**RE: Lobo LL Field Expansion at Balduini Park**  
**Grading Plan**  
**Stamp Date: 8/7/17**  
**Hydrology File: H16D149**

Re: Lobo LL Field Expansion at Balduini Park  
Grading Plan  
Stamp Date: 7/13/17  
Hydrology File: H16D419

Re: City Lobo LL Field Expansion at Balduini Park Grading Plan  
Engineer's Seal Dated July 13, 2017, City Project No. 658100

| Sheet | Of |

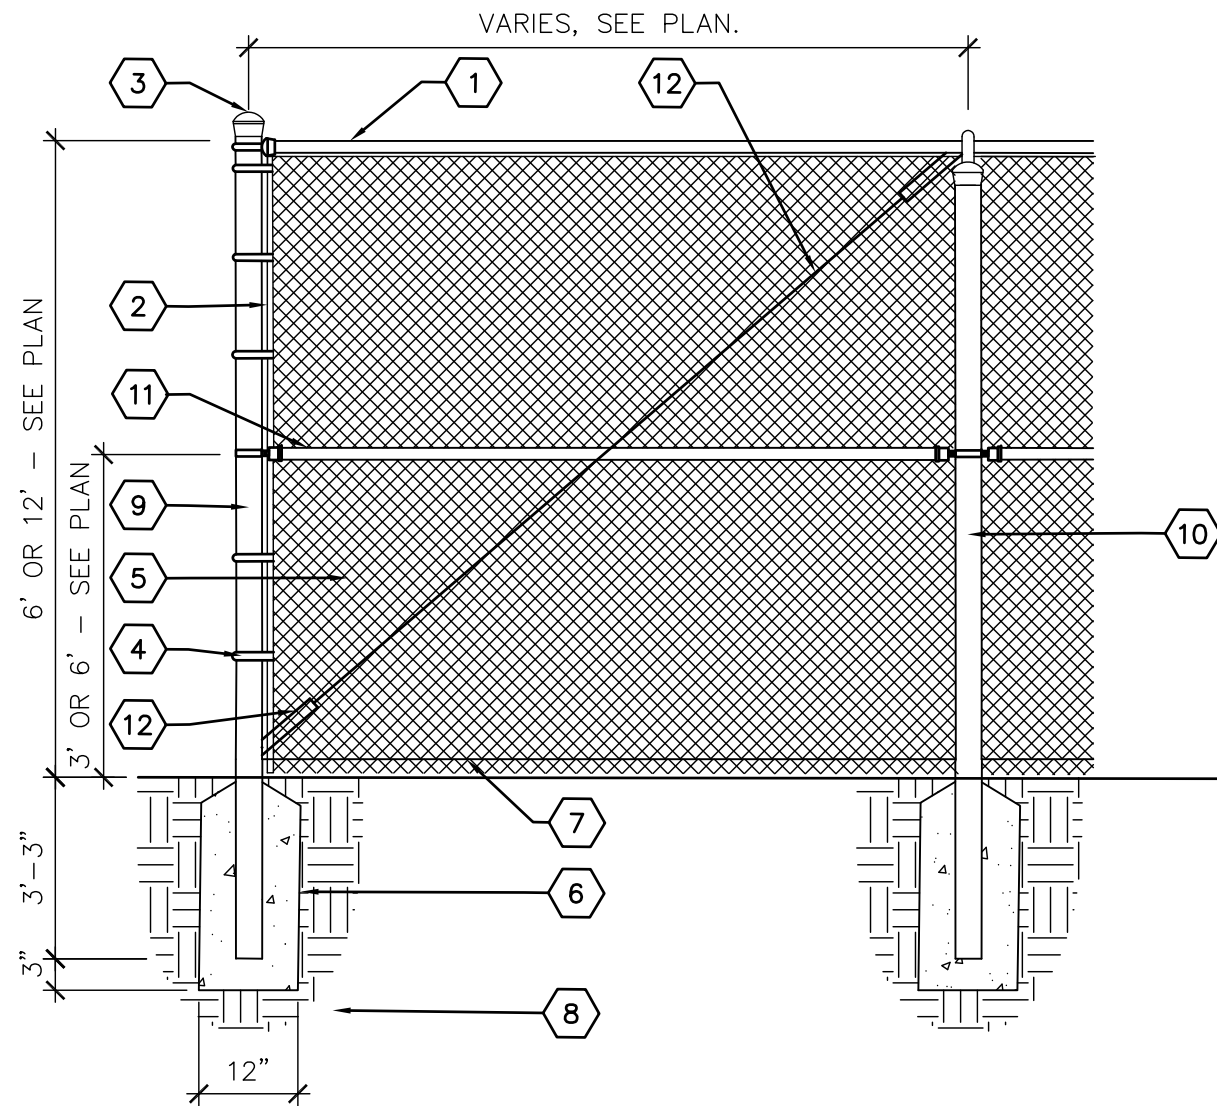
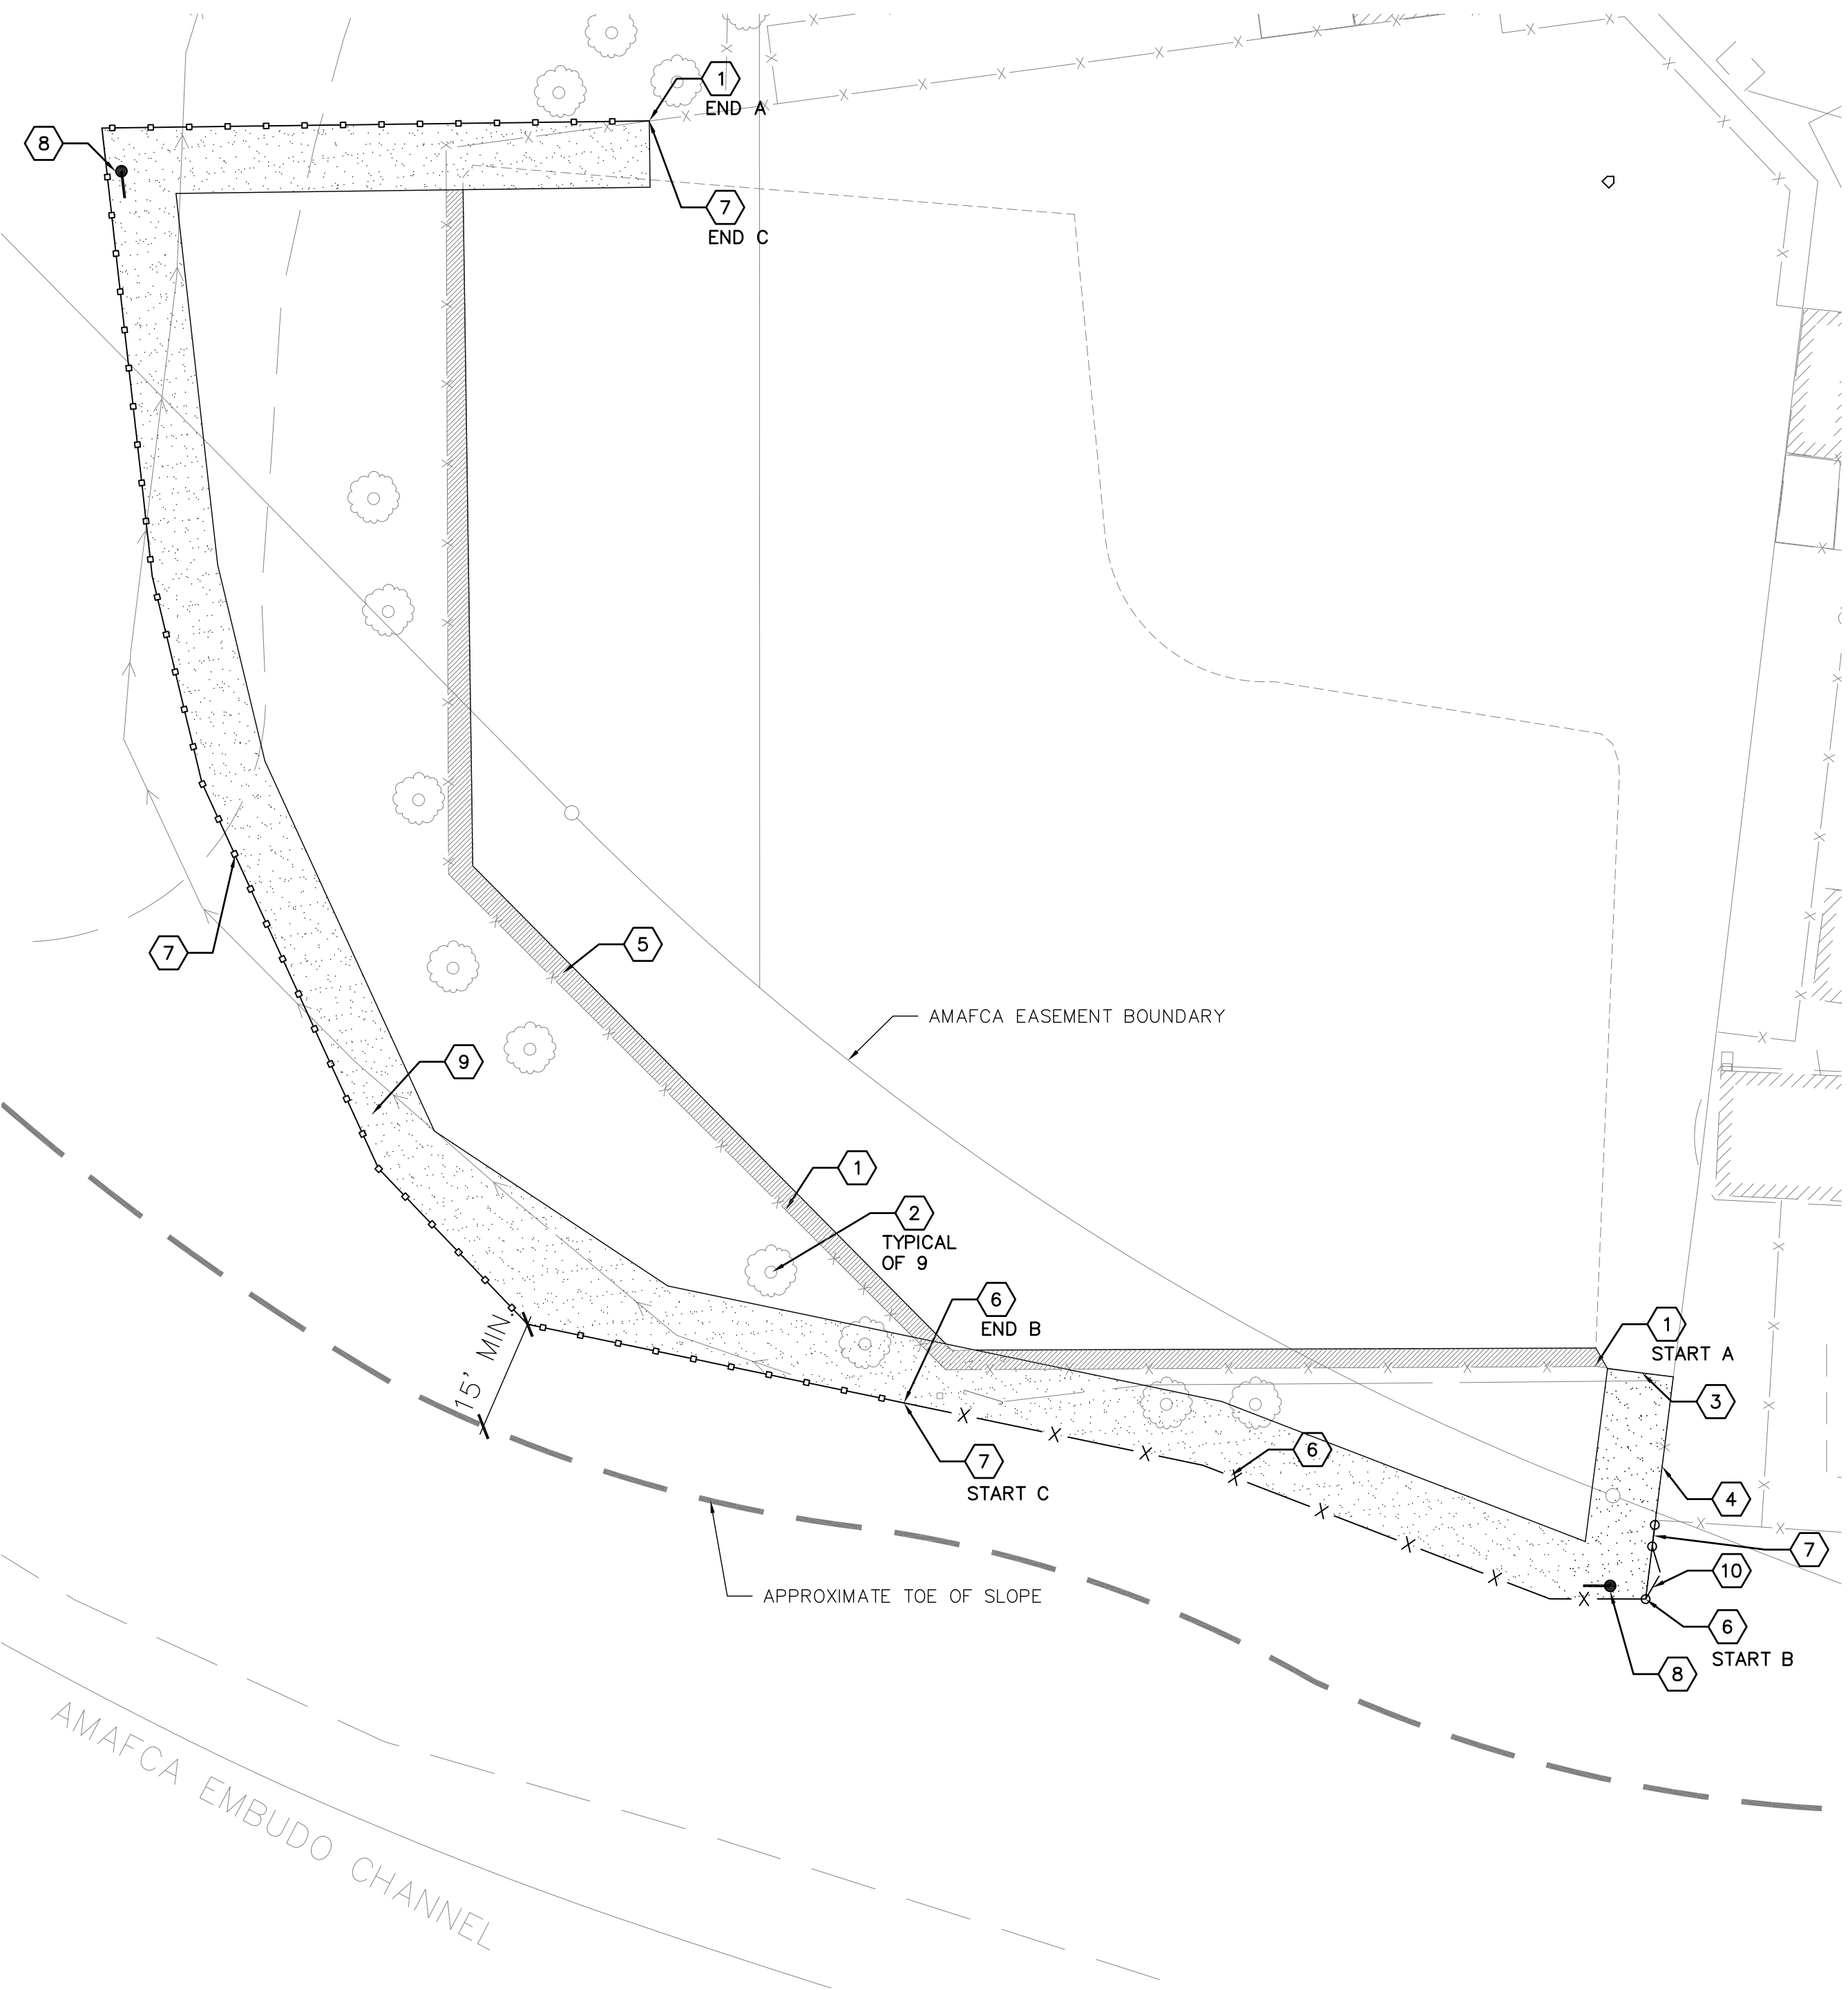
1. Show a minimum offset from the approximate toe of slope to the new fence as 16 feet. AMAFCA typically wants an offset of at least one foot from the edge of the maintenance road to a fence or wall so large transport trailers are not squeezed in.
2. Check the radius of the relocated maintenance road near the north end of the field as shown on attached Sheet 2. The typical minimum turn radius is 30 feet.
3. Add the attached General Notes to the plans.
